Re: Donaldson-Bannister Farm Blacksmith Shop Renovations

Donaldson-Bannister Farm Blacksmith Shop Renovation

Subject: Structural Assessment & Repair Recommendations
Donaldson-Bannister Shop Renovation
Project No. 25027

Report – Limited Structural Assessment & Repair Recommendations
City of Dunwoody
Donaldson-Bannister Shop

Figure 1 – Overall view of blacksmiths “Shop”. Ensure proper drainage is present.

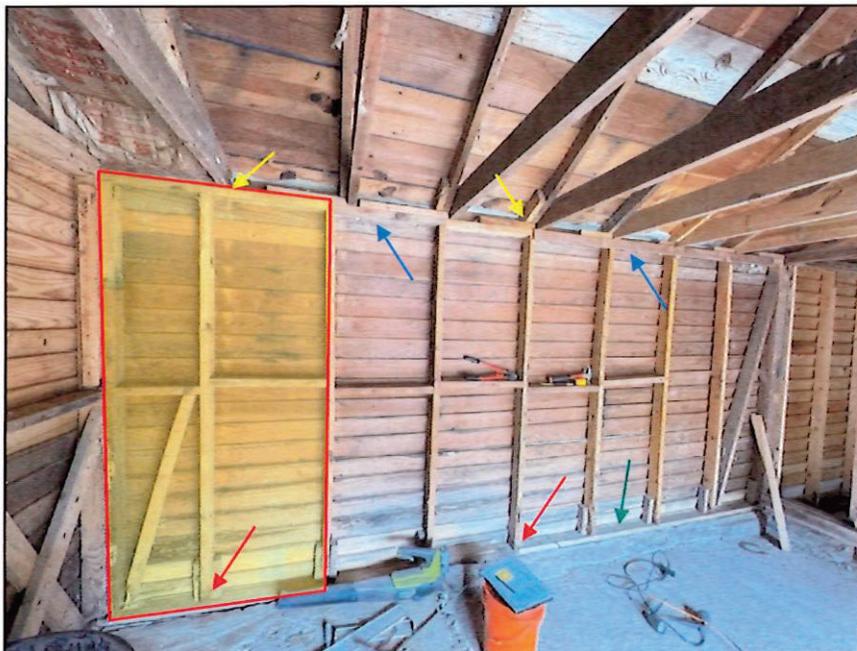
6. Drainage:
- 6.1. We recommend ensuring that no sitting or ponding water be allowed to rest at the base of the wall. All water runoff should be directed away from the building to prevent deterioration of the wood components at the base of the structure.

Figure 5 – View, looking North, of interior framing. Installation of new 2x4 stud (red arrows); repair of concrete “curb” foundation (blue arrow); and repair of cracks in slab-on-ground (yellow arrow); green lines show location of new 2x4 blocking; anchorage for bottom plate (green arrow).

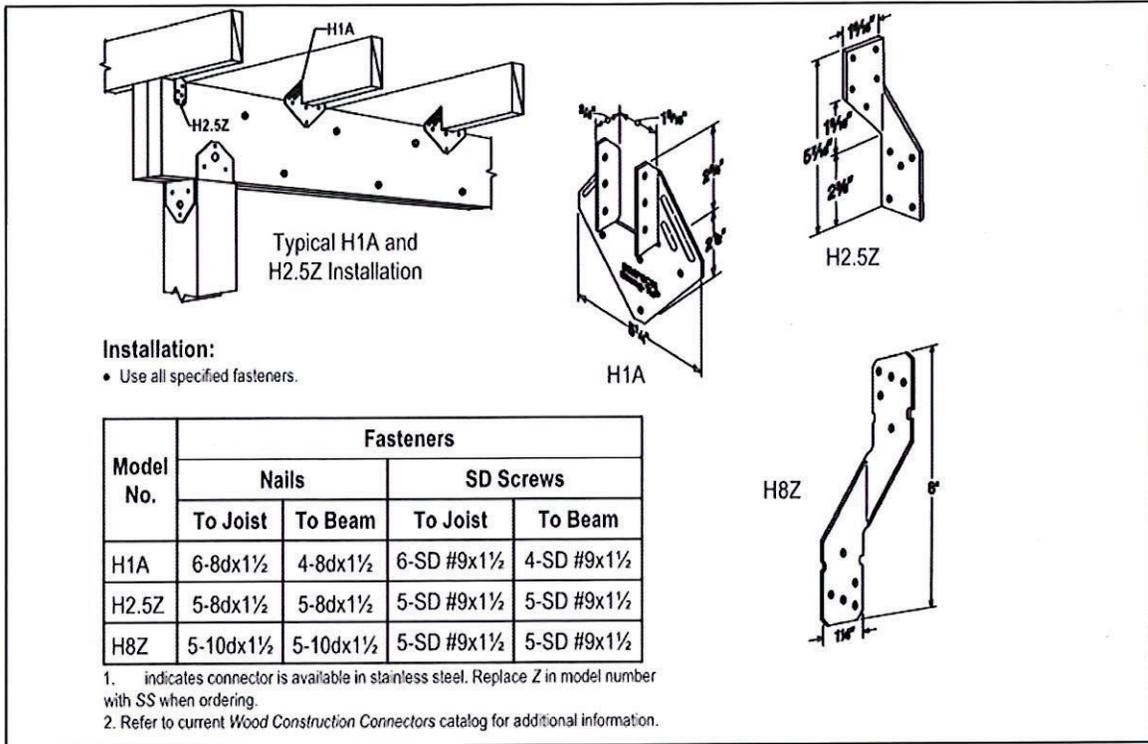
- 2.6. Installation of a new 2x4 stud at locations where the top plate is not supported (see figure 3 or 4).
 - 2.7. Remove and replace 2x4 studs that are not continuous from bottom to top plates (see figure 3).

Figure 6 – Close up of needed stud from Figure 5 (red arrow).
